Access Compliance Report Public Rights-of-Way (Curb Ramps)

Main Street: FAIRMONT_WAY Cross Street: SANTA_CLARA_AVE Location: NE

ADA ID: RPRK220127115658 Ramp Type: Type 4 - Parallel Initial Pass/Fail: Pass Overall Compliance: No Severity Score: 5

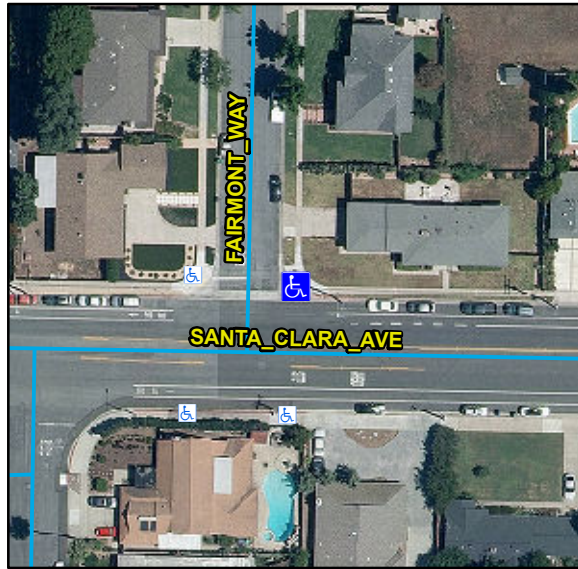
Crossing 1 Slope (%)	1.8		Crossing 2 Slope (%)	11.7
	Crossing 1 Cross Slope (%)	2.2		Crossing 2 Cross Slope (%)	0.7
Yes	Gutter Ponding	No	Yes	Curb Slope	2.6
Yes	Gutter Lip Height (in)	0		Road Run Slope (%)	2.6
No	Gutter Run Slope (%)	6		Road Cross Slope (%)	1.9
Yes	Gutter Cross Slope (%)	1.4	Yes	Perpendicular Joint Present	Yes
Yes	Overall Surface Condition	Acceptable			
	Cross Gutter Present?	Yes		Spandrel Present?	Yes
	Replace Cross Gutter?	No		Replace Spandrel?	No

Remove & Replace Gutter.

R304.5.4, STD 1115
